bushfire protection assessment addendum

Proposed Residential Aged Care Facility
Lot 3 DP 805710
181 Forest Way, Belrose

August 2018
(Ref: 18MORR02)

Figure 1.2 – Current site plan

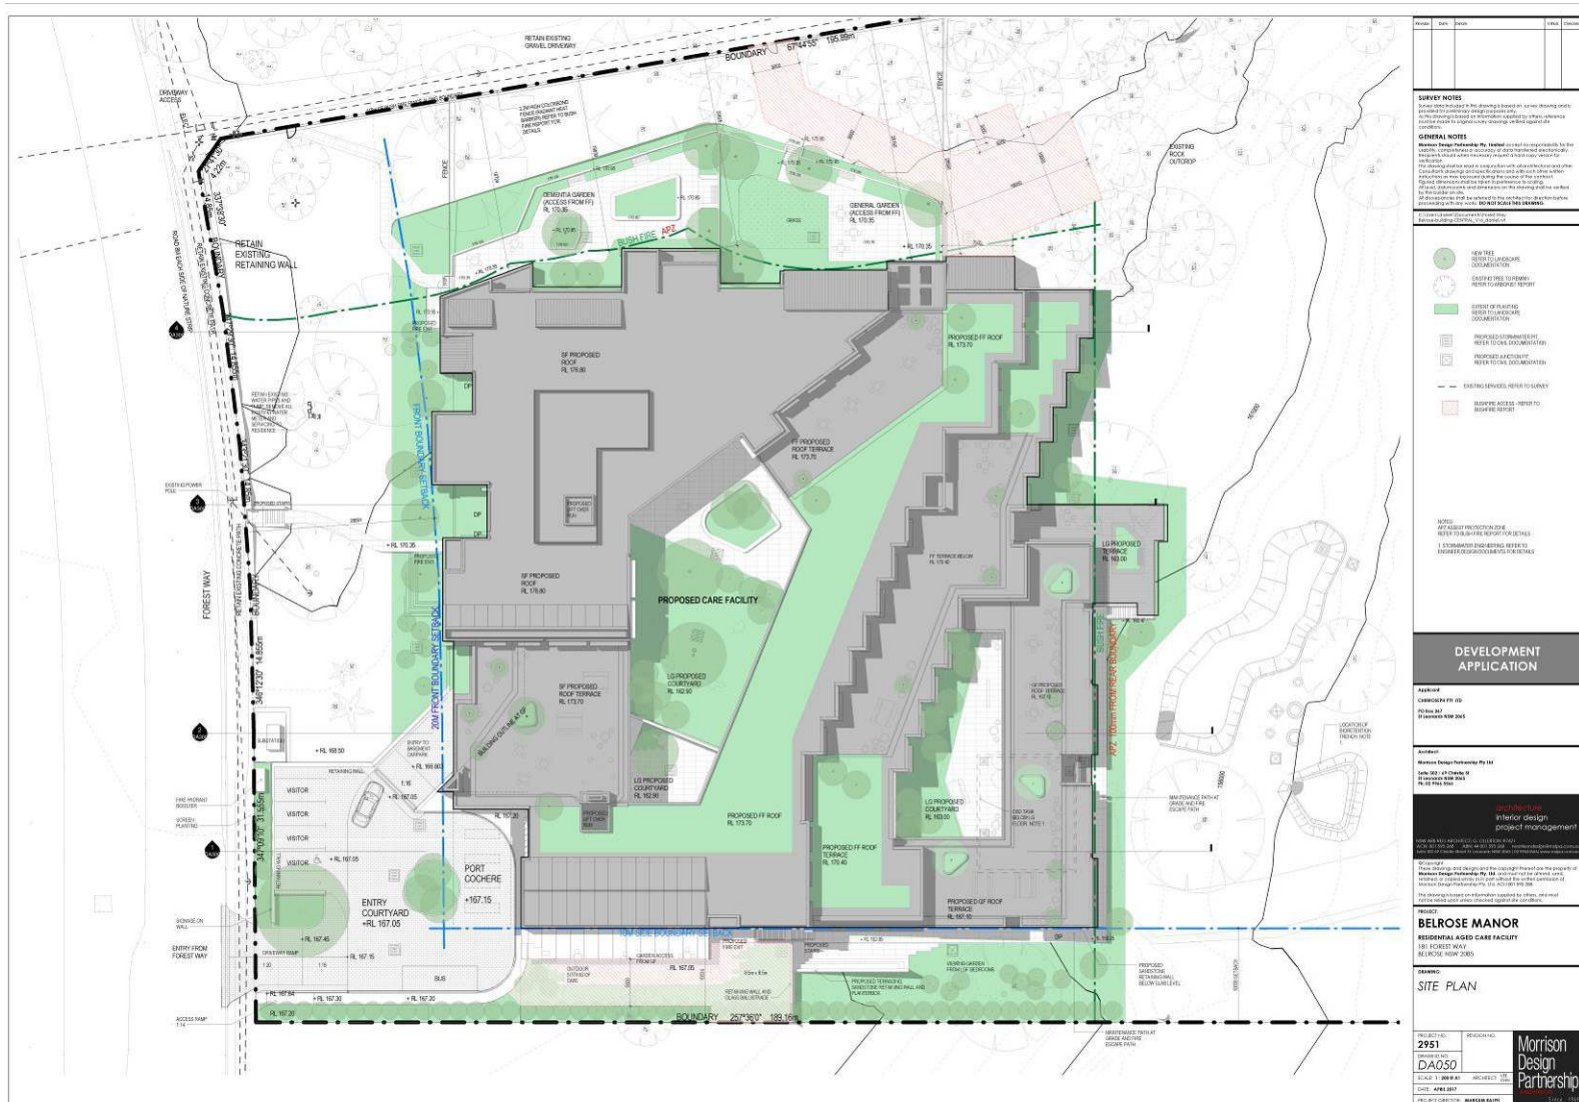
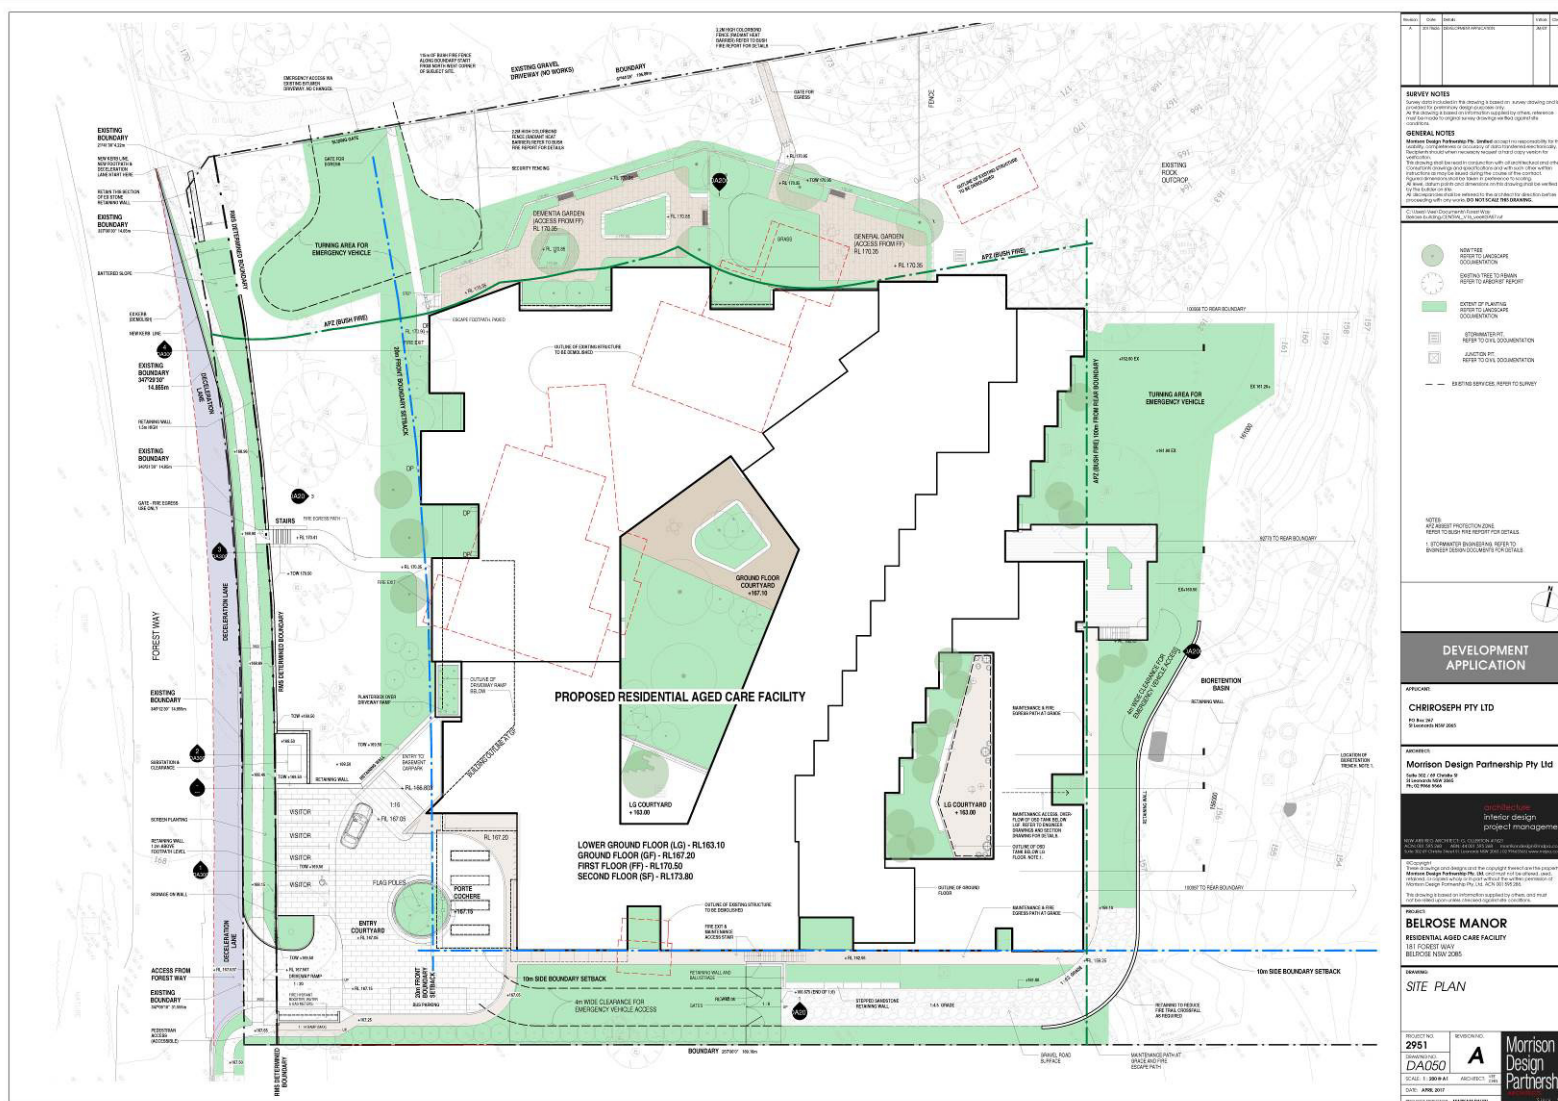
No details of the fence have been provided on the architectural plans submitted with the applications. The fence must be included on these plans to enable a full and proper assessment of the proposal.

The Site Plan submitted with the application includes details of the proposed fire trails, however the recommended fire trail parallel to the southern boundary of the site does not extend to the rear of the site and conflicts with structures proposed along this elevation (outdoor seating, stair case, retaining walls etc.). Therefore insufficient information has been submitted with the application to demonstrate compliance with the recommendations of the Bushfire Protection Assessment.

The site plan has been updated to include the construction of a 2.2m high colourbond fence along the northern boundary of the site. A sliding gate will be incorporated into the fence to ensure access to the emergency turning area. This gate is to be installed with a lock which complies with the requirements of the NSW RFS.

The site plan has been updated as per the recommendations of the bushfire report to include a trafficable fire trail which extends along the southern and eastern elevation of the building.

TITLE
Schedule 1 - Bushfire Protection Measures

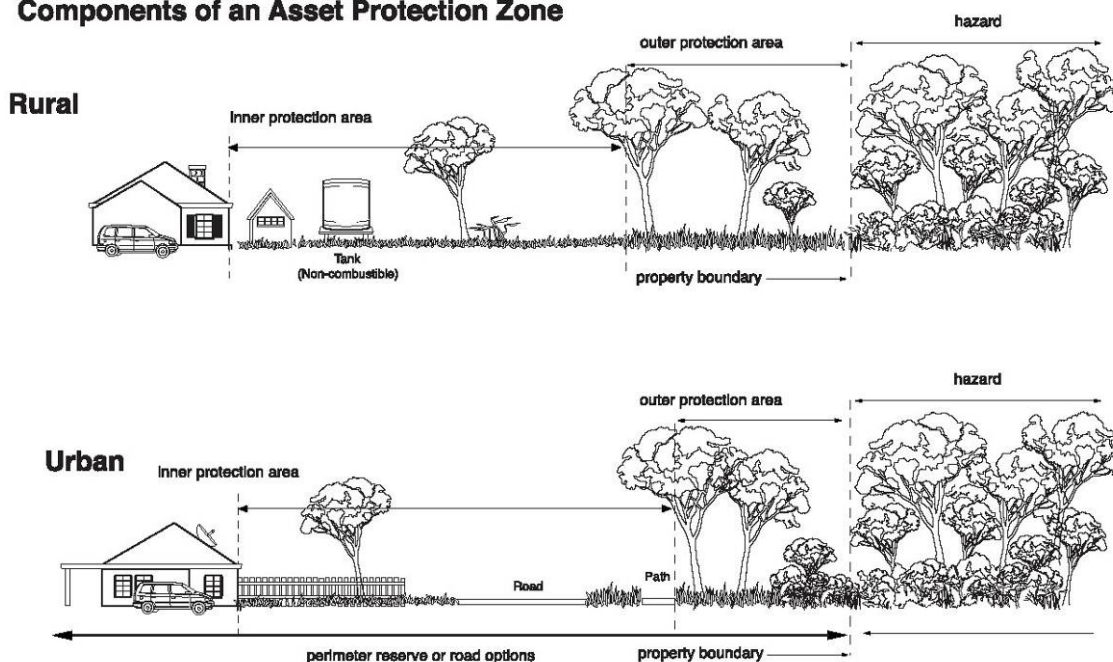
NSW RFS Response 1: Written confirmation from the adjoining land owner/s to the south of the subject site that they consent to the ongoing management of their property as an asset protection zone in perpetuity. In this regard an easement will be required over the adjoining property to ensure that the recently cleared vegetation is not re-established and threaten the aged care facility.

The application is supported by a Bushfire Report (refer to 'Bushfire Protection Assessment' prepared by Travers Bushfire & Ecology dated July 2017). The report provides recommendations to ensure that the development is in accordance with, or greater than, the requirements of PBP. The following recommendations have been made where insufficient information has been provided to demonstrate the development is capable of achieving compliance or to undertake an assessment of the impact of such recommendations:

'Recommendation 3 – A 2.2 m high colourbond fence (radiant heat barrier) is to be constructed along a portion of the northern boundary as shown in Schedule 1 attached.'

TBE can confirm that the adjoining land owner will not agree to an easement on their land. Based on the RFS assumption that the vegetation to the south will be re-established, *TBE* has undertaken a further assessment to determine the bushfire risk posed. Assuming a worst case scenario, the area in question could re-establish to a 'tall heath formation'. As outlined in Section 3.2 of this report an adequate asset protection zone (APZ) setback within the property can be provided to reduce radiant heat to <10kW/m².

Table 2.1 provides a summary of the revised bushfire assessment for the south-eastern aspect of the site (identified in bold text). This assessment assumes re-establishment of tall heath to the east of the existing tennis court. The land between the tennis court and Forest Way consists of rocky landscaped gardens, a pool and manicured grassland surrounding the dwelling (refer Schedule 1 attached). Two design fires have been used, one based on a 10m flame width (based on the angle of impact and managed land provided by the tennis court) and a 100m flame width, as depicted within Schedule 1 attached.
